SOUTHERN DOWNS REGIONAL COUNCIL

SPECIAL MEETING OF COUNCIL

4.1 Material Change of Use - Rose City Centre Pty Ltd, 71-81 Grafton Street and 76-84 Fitzroy Street, Warwick

Southern Downs REGIONAL COUNCIL	Report To: Special Council Meeting	
	Reporting Officer:	Meeting Date: 14 November 2014
	Senior Planning Officer	File Ref: MCU\01583

VIEW TOWARDS NEW CENTRE ENTRY - FITZROY & PALMERIN STREET

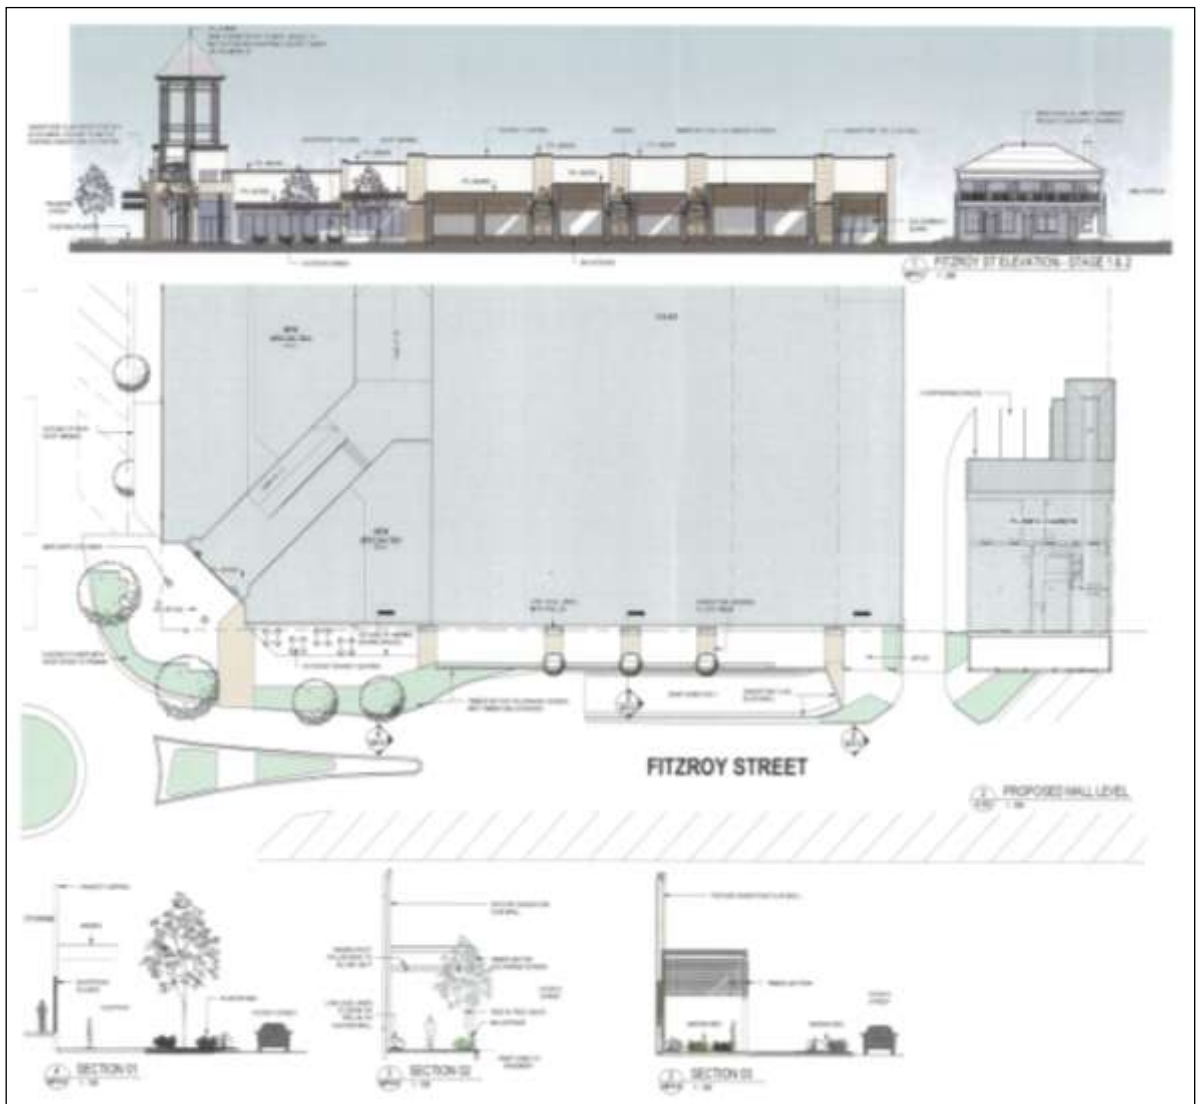
There are square topped parapets proposed along the Fitzroy Street frontage.

The Fitzroy Street elevation includes windows toward the Palmerin Street corner, including an outdoor seating area, however there is a large section of unbroken wall. The applicant has proposed a variation in building materials and heights of the awnings, street trees and trelliss to reduce the bulkiness of the elevation.

The speciality tenancy which has frontage to Fitzroy Street, has approximately 18 metres of glass shop front. There is approximately 45 metres of blank wall along the Fitzroy Street elevation, which equates to 64% of the total elevation.

Councillors have raised concerns with officers regarding the potential for increased crime along the Fitzroy Street frontage, as there are limited windows within the elevation. Crime in the city centre generally occurs after business hours, after midnight such as the recent burglary of the Palmerin Street Jewellery store. Additional windows in that facade will not assist in reducing crime as the business will not be operational when crime takes place. Council's Information Services department have reviewed the proposal and the current CCTV CBD system. It is considered appropriate that CCTV cameras are installed to ensure surveillance coverage of the footpath area under the awning along Fitzroy Street.

The applicant proposes awnings over the Fitzroy Street footpath, however the awnings are broken to allow for the trellis protrusion.

8. The design, colours and materials of the building and footpath pavement are to be in accordance with the character of the area and the existing Rose City Shoppingworld building, and subject to the following changes:

- The awnings on the Palmerin Street and Fitzroy Street frontages of the new building are to be extended to allow weather protection for pedestrians to the new pedestrian entrance to the Shopping centre.

- The awning is to extend along the full frontage of the Fitzroy Street frontage of the new building. There are to be no breaks/gaps in the awning, i.e. breaks to allow for the trellis.

- The blank wall under the awning, along the Fitzroy Street frontage of the new building, is to be treated with a variety of design elements to enhance the appearance of this wall. These works are to include variations to surface treatments, colours, materials, and other design elements, and at least two additional colourback glass windows are to be included within the Fitzroy Street elevation of the building, under the awning.
